<b>CITY OF WESTMINSTER</b>			
<b>PLANNING APPLICATIONS SUB COMMITTEE</b>	<b>Date</b> 3 October 2023	<b>Classification</b> For General Release	
<b>Report of</b> Director of Town Planning & Building Control		<b>Ward(s) involved</b> Abbey Road	
<b>Subject of Report</b>	62 Clifton Hill, London, NW8 0JT		
<b>Proposal</b>	Erection of roof extensions, a side extension at lower-ground floor level, minor internal and external works, alterations to the boundary treatment and landscaping scheme.		
<b>Agent</b>	Ms Elizabeth Woodall		
<b>On behalf of</b>	Mr Vic Aswani		
<b>Registered Number</b>	23/02503/FULL & 23/02504/LBC	<b>Date amended/ completed</b>	25 April 2023
<b>Date Application Received</b>	14 April 2023		
<b>Historic Building Grade</b>	Grade II		
<b>Conservation Area</b>	St. John's Wood		
<b>Neighbourhood Plan</b>	Not applicable

Refuse permission and listed building consent – on the grounds of inappropriate design, harm to the listed building, harm to the setting of the neighbouring listed building at No.64 Clifton Hill, and harm to the surrounding St Johns Wood Conservation Area.

### Proposed Lower Ground Floor and Ground Floor Plans

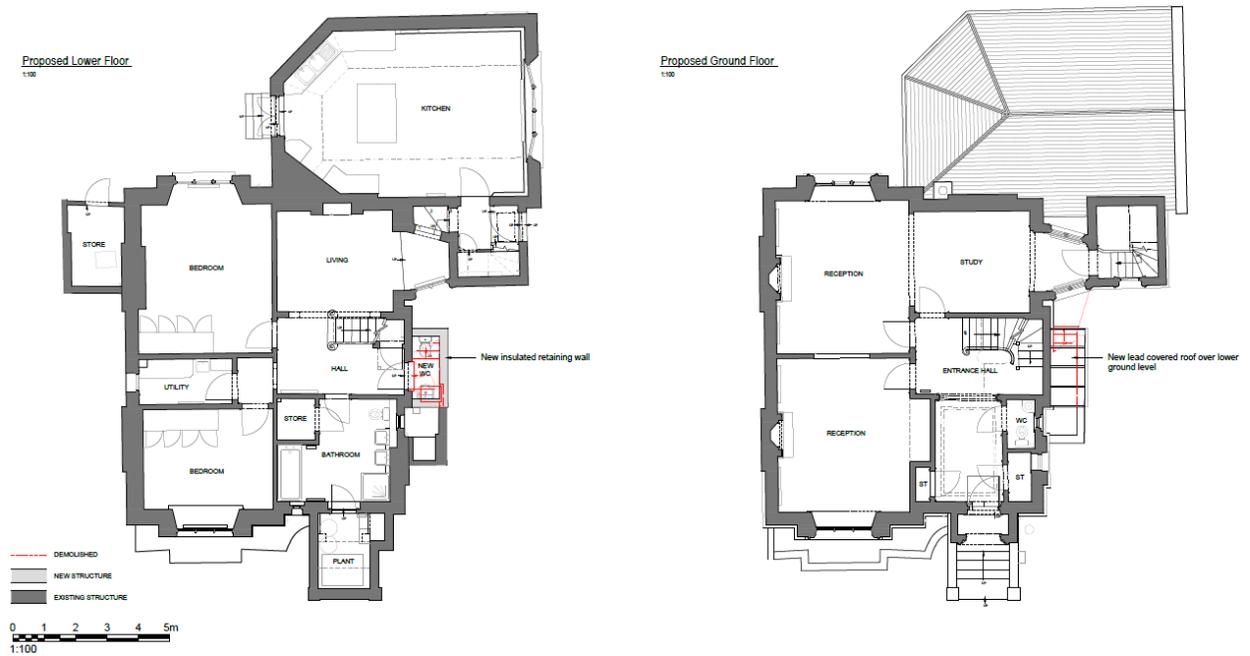
The proposed small lead roofed extension is roughly in the position of the previously approved glazed roofed extension, set down within an existing lightwell at lower ground floor level. Its traditional design and small size will ensure it integrates successfully with this elevation.

### Proposed Roof Plan

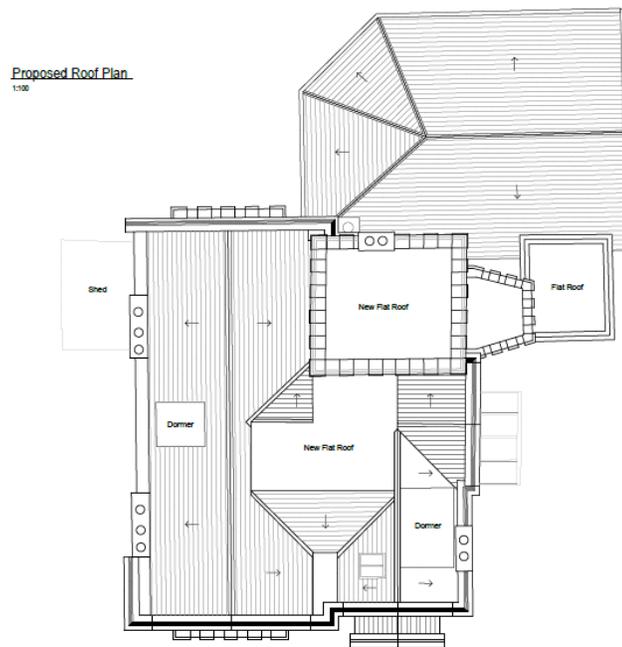
Regardless of the acceptable aspects of the scheme, the turret extension, proposed to be erected at the location of the existing roof terrace, is considered the wrong form of roof extension for a house of this type. Although there are larger houses in the local area where castellated towers are part of the original design, houses of the same type / size as that on the application site were not designed with these and no similar high level turret extensions have been added to any of the houses of the same size / type in the local area. The height and mass of the proposed turret extension would make it much more visually prominent than the gables that define the roofline of this house and the most visually dominant feature of the building.

In addition, a large part of the external wall facing the terrace will be removed to provide an internal link to the new extension. This will erode the plan form and involve the loss of historic fabric.

For the reasons above, the turret extension and the associated internal alterations are considered to harm the architectural and historic interest of this listed building, the setting of the nearby listed building at no.64 Clifton Hill and the character and appearance of the St. John's Wood Conservation Area. The level of harm that would result from the proposals is considered at the moderate end of less than substantial. Paragraph 202 of the National Planning Policy Framework (NPPF) states that where a proposal would lead to less than substantial harm to the significance of a heritage asset, this harm should be weighed against the public benefits of the proposal. In this instance, the property is already in its optimum viable use and there would be no public benefits resulting from the proposed works to offset the degree of harm caused.
